1984 Corvette: Service Bulletin: Broken Window Regulator Tapes

Model and Year: 1984 Corvette

Bulletin No: 84-3

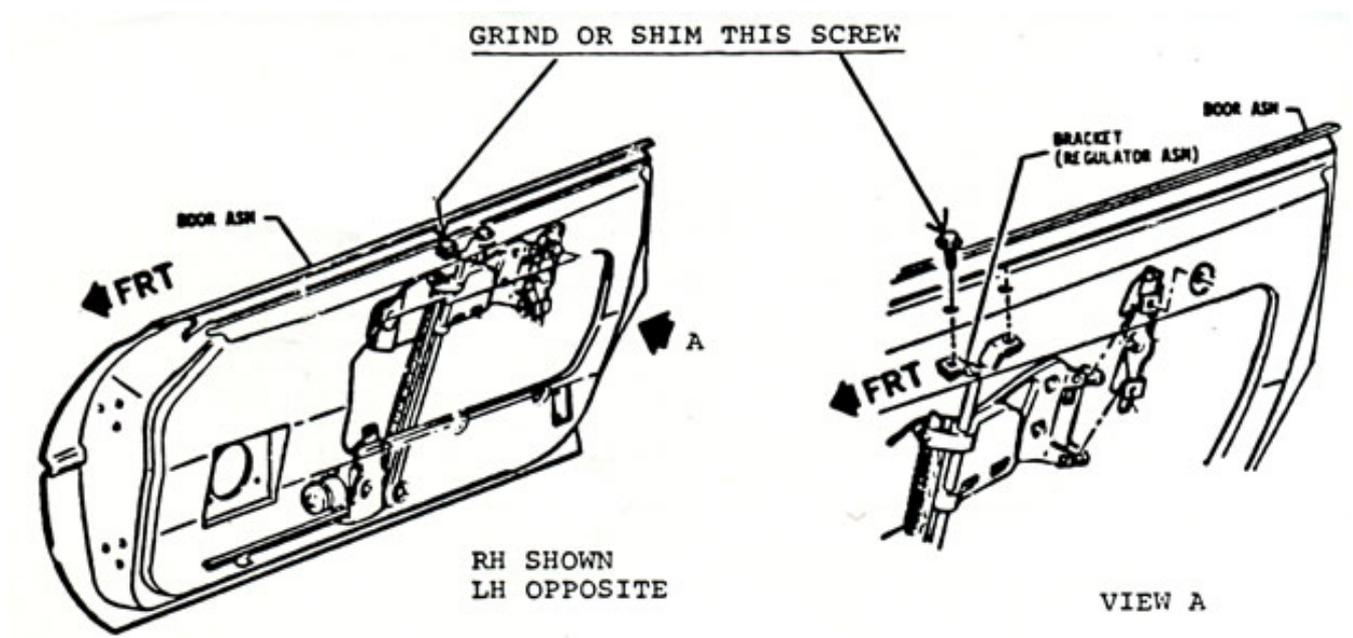
Whenever a vehicle requires service of door components, inspect for interference between the forward upper attaching screw and the upper end of the tape drive. If interference exists, one of the following options should be performed:

This is to prevent contact between the bottom of the screw and the upper end of the tape drive. If this contact exists, excessive stress is created in the tape and could cause a failure.

1. Add a washer (P/N 14038397), or equivalent, under the upper forward attaching screw (See Illustration).
2. Remove the forward attaching screw (P/N 11503800) and grind approximately 3mm from the threaded end.
